PCI-SIG ENGINEERING CHANGE NOTICE

TITLE:	Transition of NFC Signals from 3.3V to 1.8V		
DATE:	October 19, 2014		
AFFECTED DOCUMENT:	M.2 Spec Rev 1.0		
SPONSOR:	Manisha Nilange and Ra'anan Sover; Intel Corp.

Change Table 15 as follows:

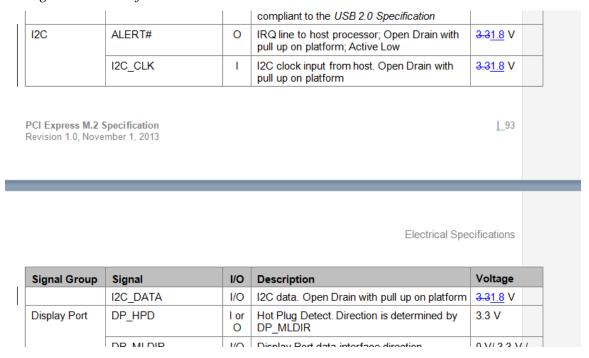
The proposed change is to change the current voltage level of the NFC related signals (I2C DATA, I2C CLK and ALERT#) on the Connectivity pinouts and definitions from 3.3V to 1.8V signal level to better align with future platforms operating signal levels typical in the industry.
